CITY OF BEVERLY
ADDENDUM NO. 2, August 15, 2016

RE: INVITATION FOR BIDS #16-035 ROOF SYSTEM REPLACEMENT AT DPW BUILDINGS

WALL &
DOOR

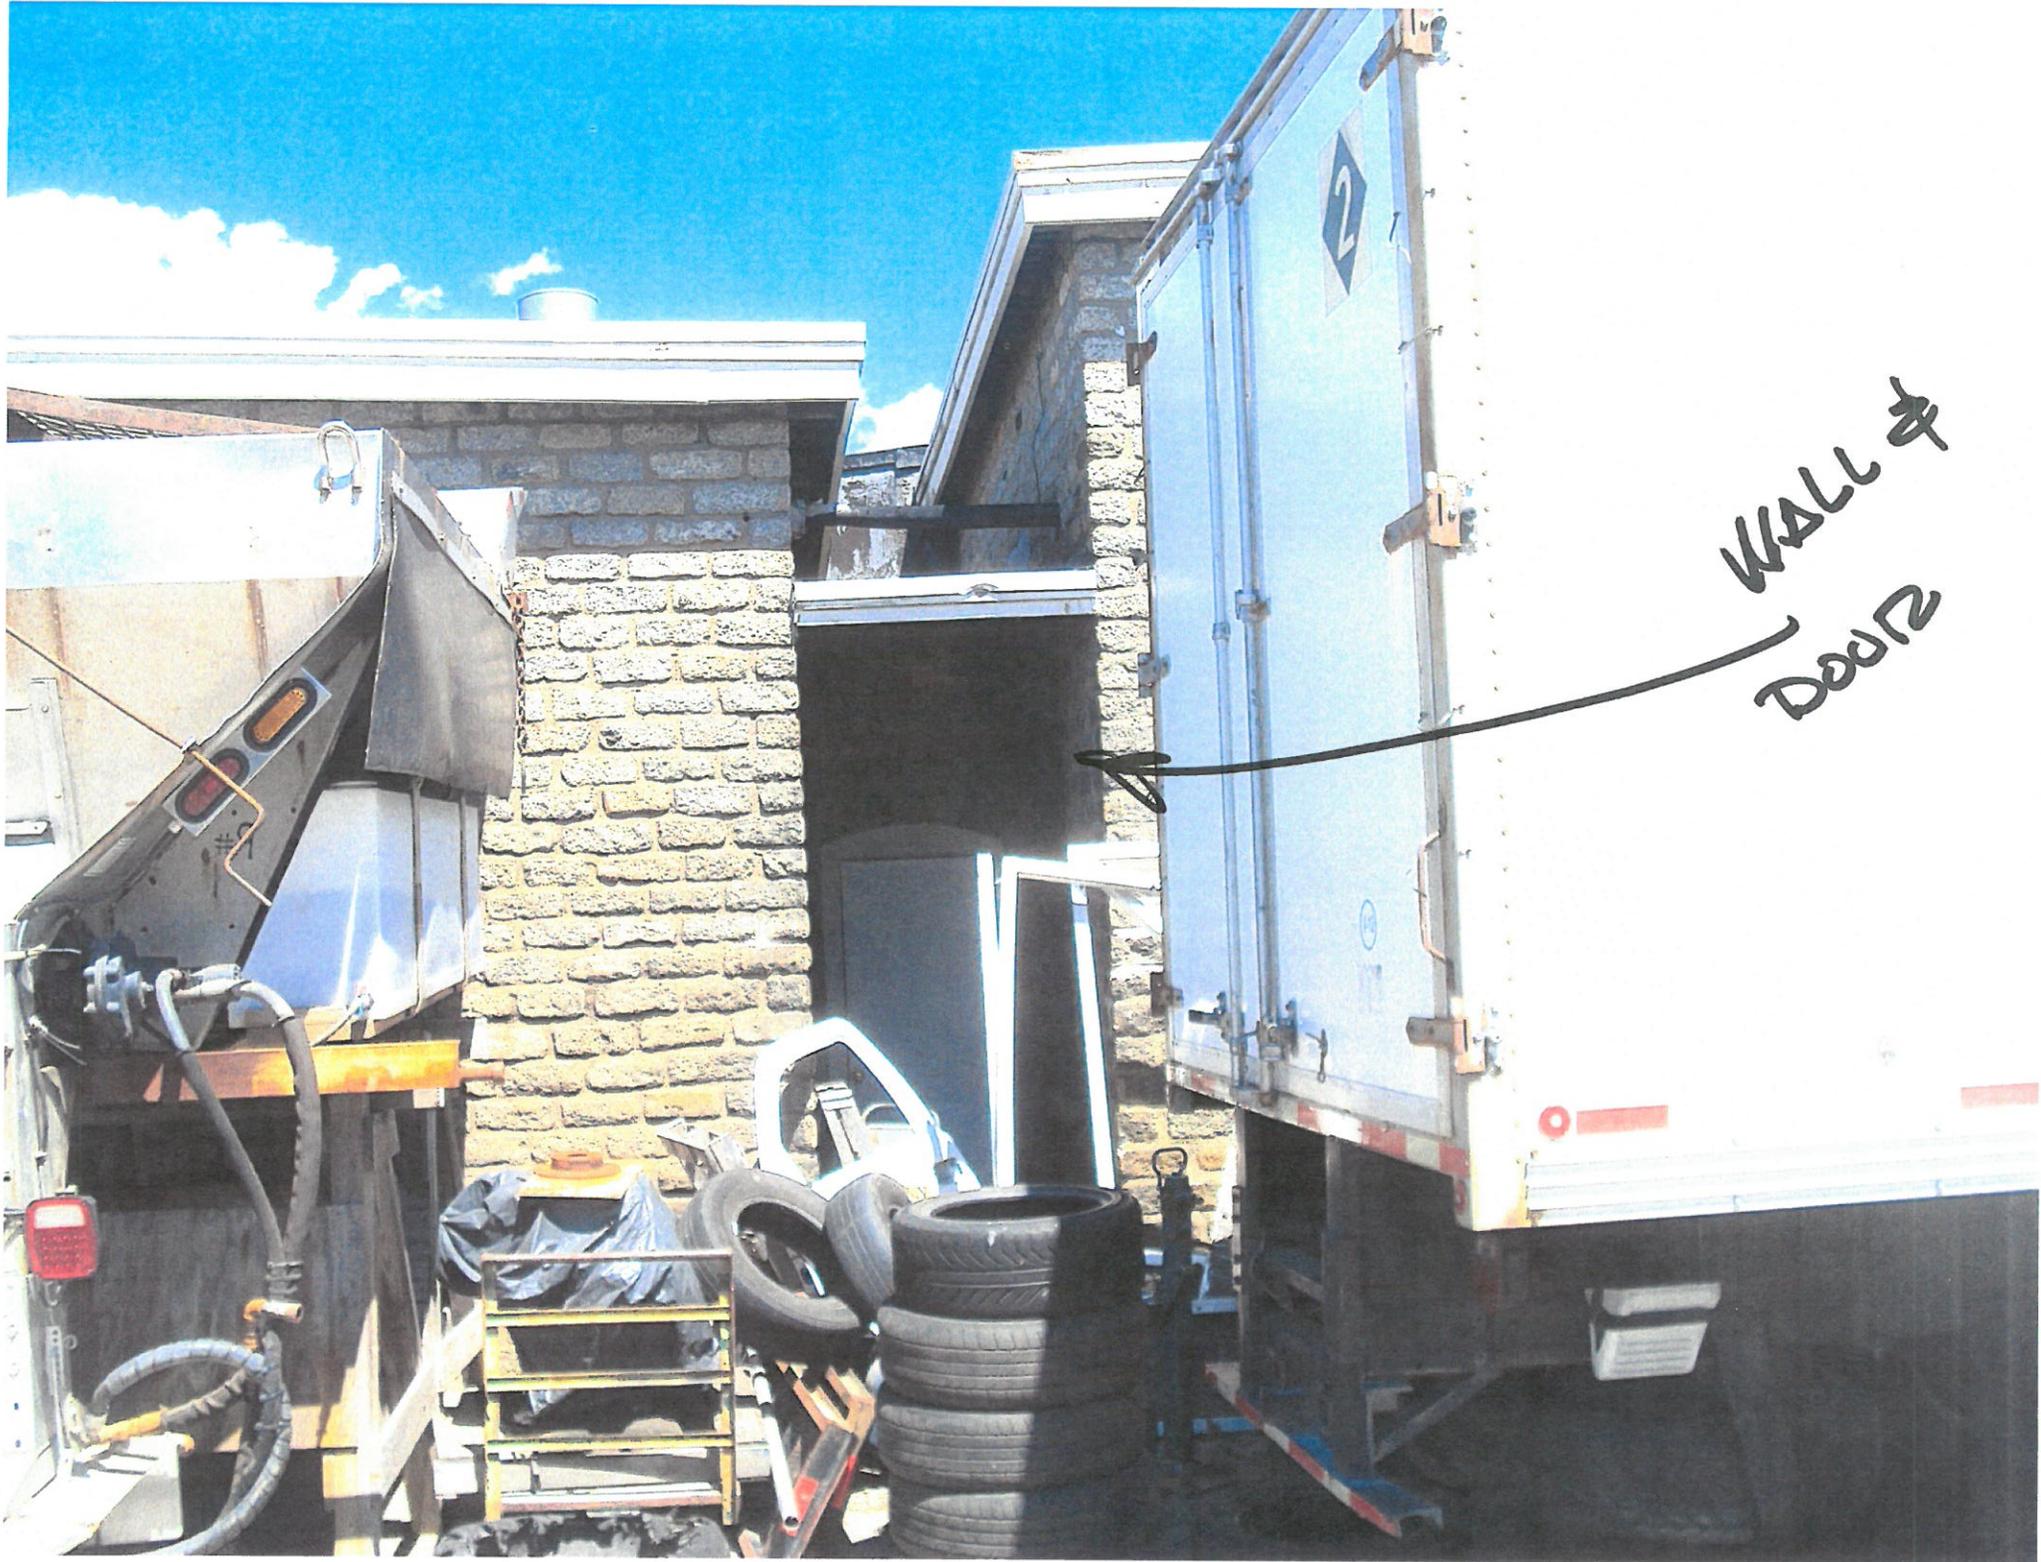
Question 4: At "Building 2" – West Elevation – at the lower BUR roof system and frame to be removed it appears that there is an existing wall and door entrance. If we remove the roof deck there will be an opening above the existing wall. Please clarify and issue detail for the wall construction to the underside of the new roof deck. See attached photo of area.

Answer 4: The contractor will infill the wall above the door with wood framing and siding to match the front of the building.
